Dominion Energy Virginia Glebe-Potomac River Project – Potomac Avenue Route

The responses below are a follow-up to questions that came out of the Working Group meeting on February 21, 2018, and are provided in a good faith effort to continue fostering transparent and open dialogue with the City, Working Group and the public regarding the proposed Potomac Avenue Route for the Glebe-Potomac River Project.

Working Group Questions (February 21, 2018 Meeting)

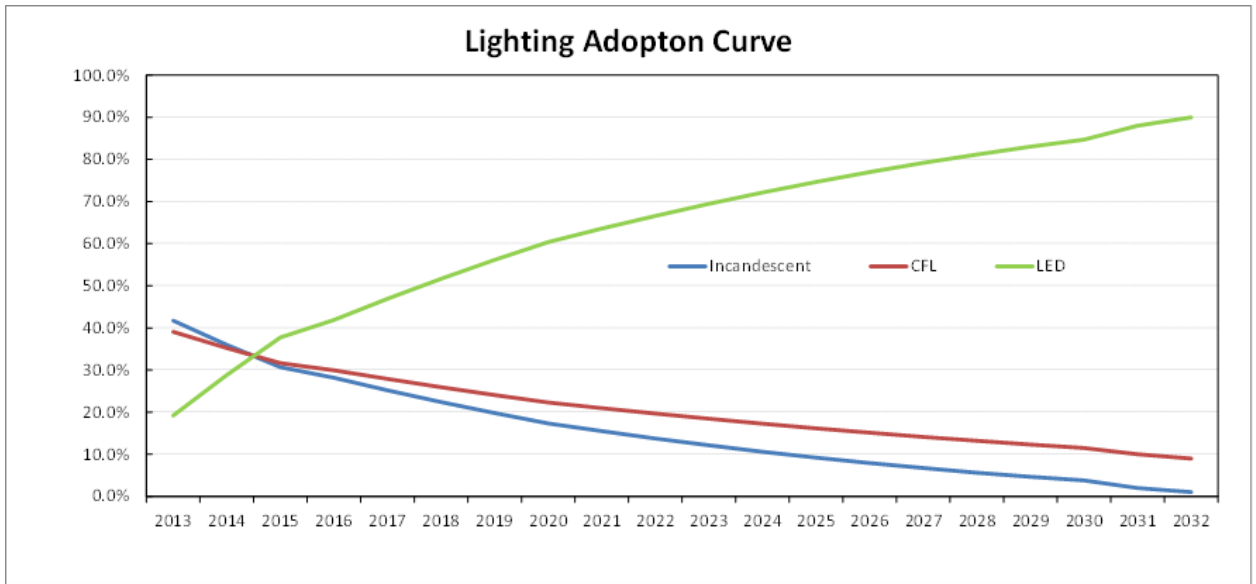
6. Regarding the reliability need, please clarify that all three options (CSX, Potomac Ave, and rebuild) meet the reliability need, described by Dominion Energy Virginia as NERC Reliability Standards violations?

To address the need, the Company is proposing the Glebe-Potomac River Project, as well as the Rebuild Alternative, both of which will equally resolve the identified violations of NERC Reliability Standards. In terms of adding system resilience, the Company believes the proposed Glebe-Potomac River Project is the best solution to the identified reliability deficiencies, and the Potomac Avenue and Railway Routes offer the minimum acquisition of new rights-of-way. Ultimately, the Virginia SCC will determine if a need exists and what project is in the public interest as part of its CPCN process in accordance with Virginia law.
